Access Compliance Report Public Rights-of-Way (Curb Ramps)

Main Street: OAK_RIDGE_DR		Cross Street: WINTHROPE_ST		Location:	NW
ADA ID: RPAT211007101920	Ramp Type:Type 1 - Perpendicular Diagonal Initial Pass/Fail: Pass		Overall Compliance: No	Severity Score:	22
Codes/Mitigation Info/Possible Solution			Field Measurements/Component Compliance

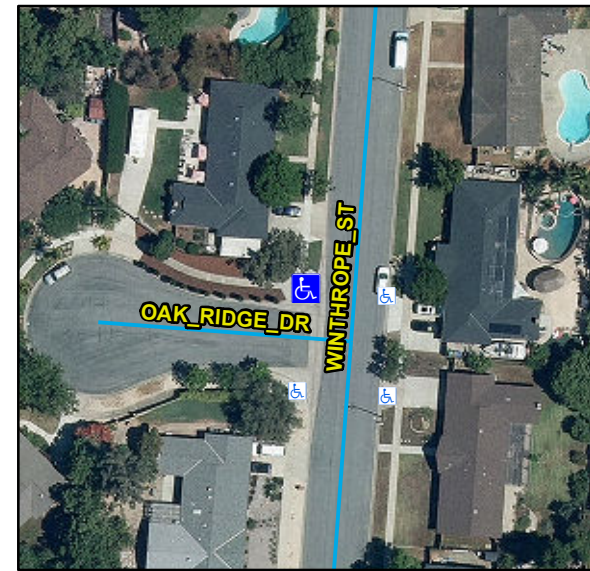
Compliance	Description	Data	Compliance	Description	Data
N/A	Ramp Length (in)	139	N/A	Flare Type LT	
Yes	Ramp Width (in)	58			Sloped
Yes	Ramp Run Slope (%)	6.5	N/A	Flare Slope LT (%)	5.5
Yes	Ramp Cross Slope (%)	0.4	N/A	Flare Traversable LT	No
N/A	Landing Present	No	N/A	Flare Type RT	
N/A	Landing Length (in)	N/A			Sloped
No	Landing Width (in)	N/A	N/A	Flare Slope RT (%)	3.2
No	Landing Run Slope (%)	N/A	N/A	Flare Traversable RT	No
No	Landing Cross Slope (%)	N/A	No	DWS Provided	No
N/A	Landing Movement Obstructed?	Yes	N/A	DWS Contrast	N/A
	Landing Movement Type	Bushes	N/A	DWS Length (in)	N/A
N/A	Landing Shared	N/A	N/A	DWS Full Width	N/A
N/A	Clear Space	Yes	N/A	DWS Offset Left (in)	N/A
N/A	Clear Space To Crosswalk (in)	48	N/A	DWS Offset Right (in)	N/A
N/A	Marked Crosswalk 1	No	N/A	Marked Crosswalk 2	No
	Crossing 1 Direction	S		Crossing 2 Direction	E
	Marked Crosswalk 1 Width (in)	N/A		Marked Crosswalk 2 Width (in)	N/A

N/A	Ramp Inside Crosswalk 1	N/A	Yes	Ramp Inside Crosswalk 2	N/A
	Crossing 1 Slope (%)	1.2		Crossing 2 Slope (%)	3.4
	Crossing 1 Cross Slope (%)	1.5		Crossing 2 Cross Slope (%)	0.6
Yes	Gutter Ponding	No	No	Curb Slope	12.4
Yes	Gutter Lip Height (in)	0		Road Run Slope (%)	0.2
Yes	Gutter Run Slope (%)	0.3		Road Cross Slope (%)	3
Yes	Gutter Cross Slope (%)	0.3			
Yes	Overall Surface Condition: Acceptable		No	Perp Joint Present	No
	Cross Gutter Present?	Yes		Spandrel Present?	Yes
	Replace Cross Gutter?	No		Replace Spandrel?	No

Remove & Replace Curb Ramp With Two New Directional Ramps or Equivalent.
